CONTRACT: D13POC.BM.31161 BRIDGE PROJECT: 18313.1011215.PR

LOCATION: *REPAIR BRIDGE #100734 ON OLD MARS HILL HWY
OVER IVY CREEK*

TYPE OF WORK: *STRUCTURE REPAIR*

ORIGINAL PE SEALS DO NOT APPLY TO PLANSET MARKUPS IN RED

FRAMING PLAN

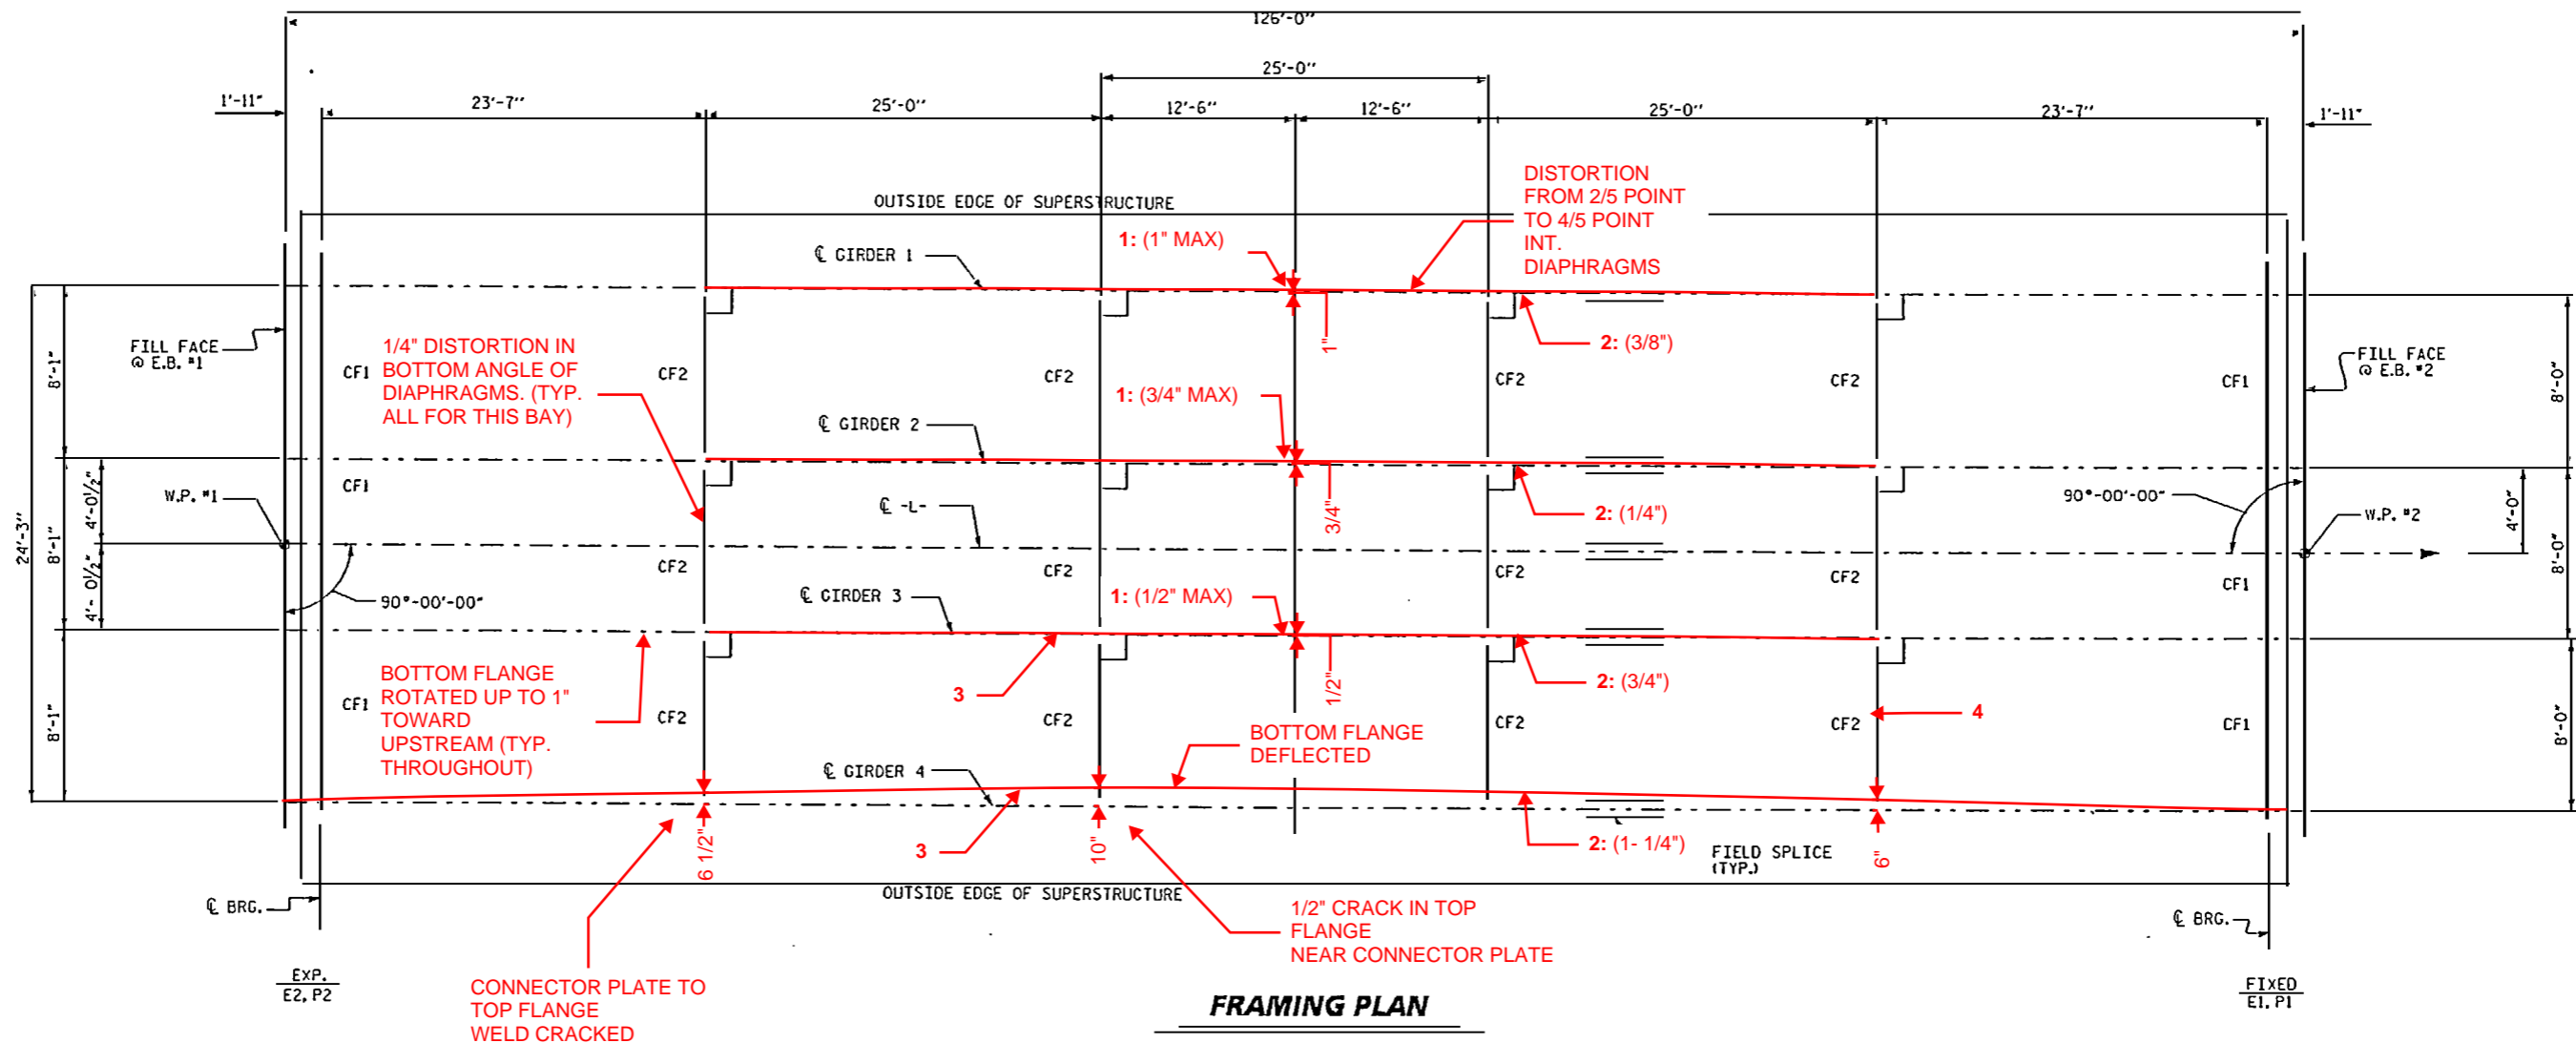
1: LOWER PORTION OF WEB DISTORTED ALONG LONGITUDINAL AXIS UP TO " MAX.

2: WEB DISTORTED ABOUT VERTICAL AXIS TOWARD LEFT AND RIGHT AT VERTICAL WELD SPLICE LOCATION

3: UP TO 1/2" WEB DISTORTION ABOUT VERTICAL AXIS TOWARD UPSTREAM AND DOWNSTREAM (TYP. BETWEEN ALL INT. DIAPHRAGMS)

4: ALL INT. DIAPHRAGMS IN BAY 3 HAVE BUCKLED W/ DISTORTION IN WEB STIFFENER PLATES AT BOLTED CONN'S.

BOTTOM FLANGE DETAIL

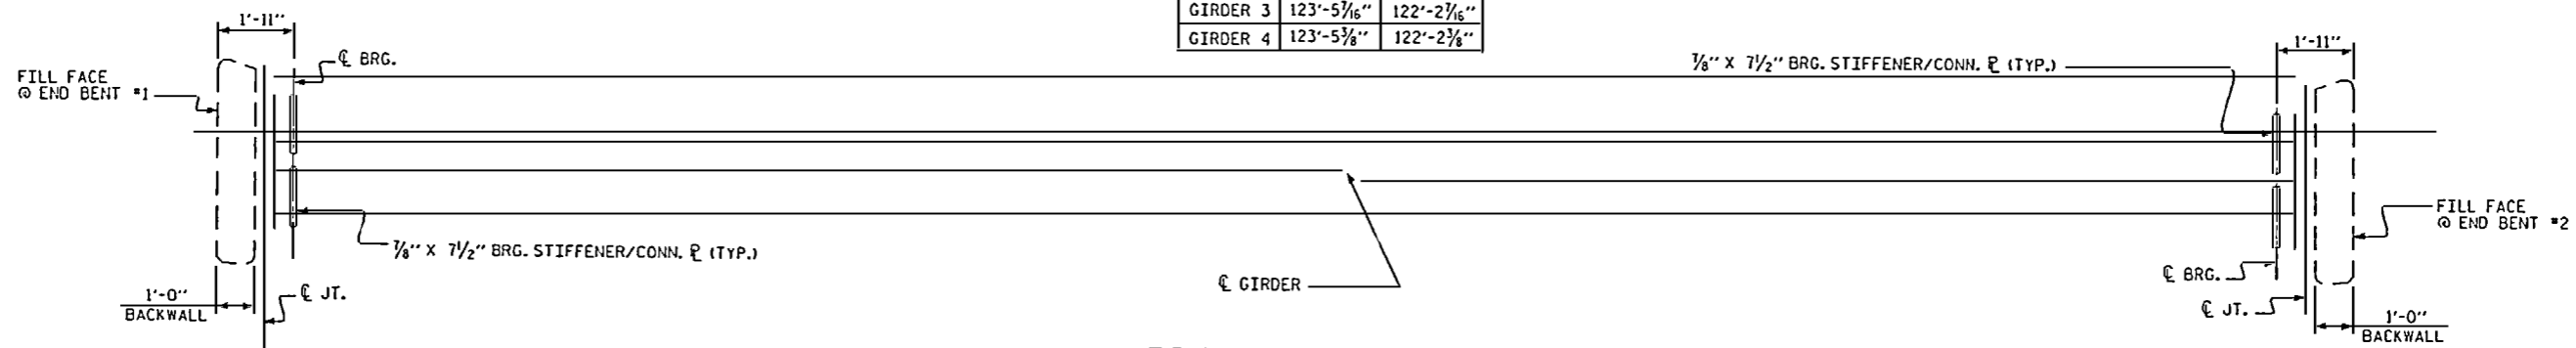
FIELD SPLICE NOT USED IN ORIGINAL CONSTRUCTION

TYPICAL INTERMEDIATE CROSSFRAME (CF2)

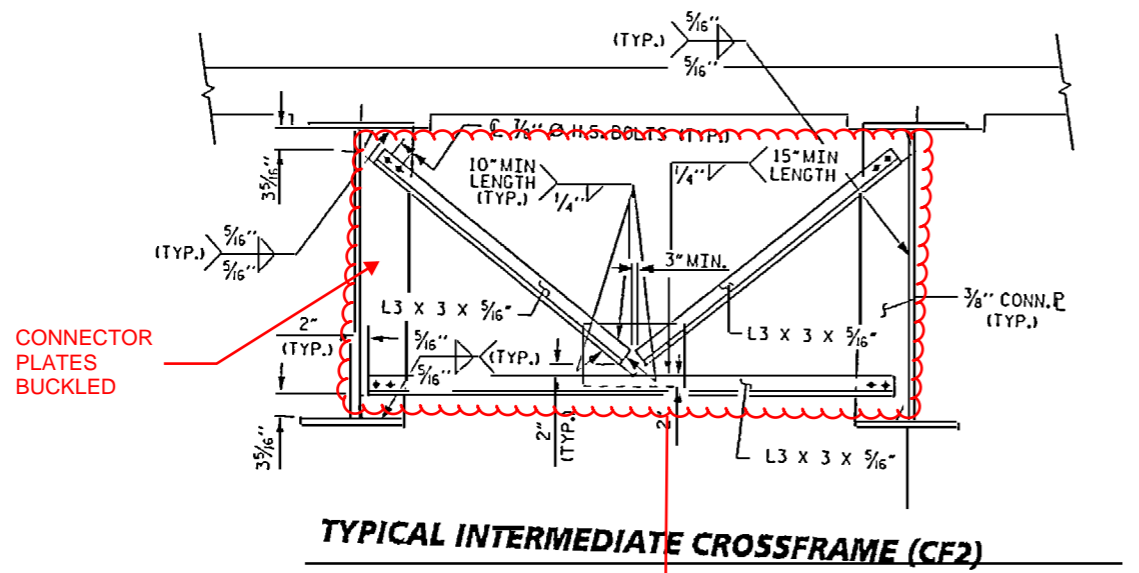
CONNECTOR PLATES BUCKLED

4 CROSSFRAMES IN BAY 3 TO BE REPLACED. REPLACEMENT OF DIAPHRAGMS IN BAY 1 AND 2 MAY BE REQUIRED AT THE DIRECTION OF THE ENGINEER.

TYPICAL END BENT CROSSFRAME (CF1)

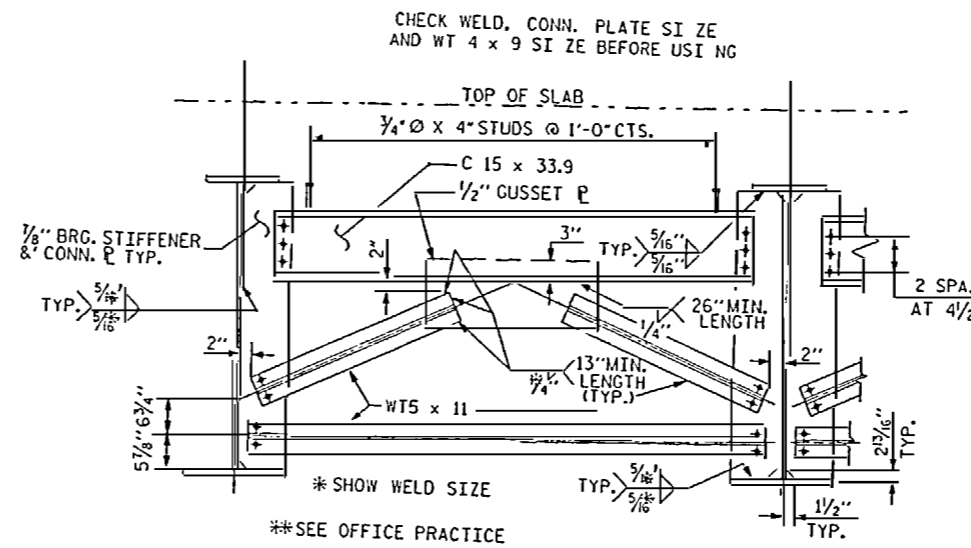
CHECK WELD, CONN. PLATE SIZE AND WT 4 x 9 SIZE BEFORE USING

**SHEAR STUD DETAIL
FOR TOP FLANGE SPLICE PLATE**

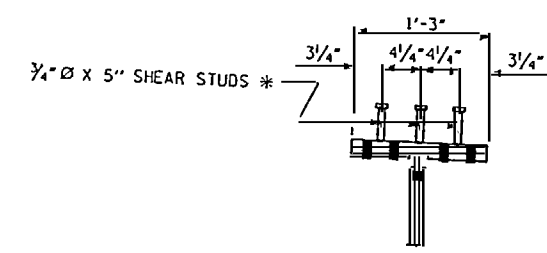
FIELD SPLICE NOT USED
IN ORIGINAL
CONSTRUCTION
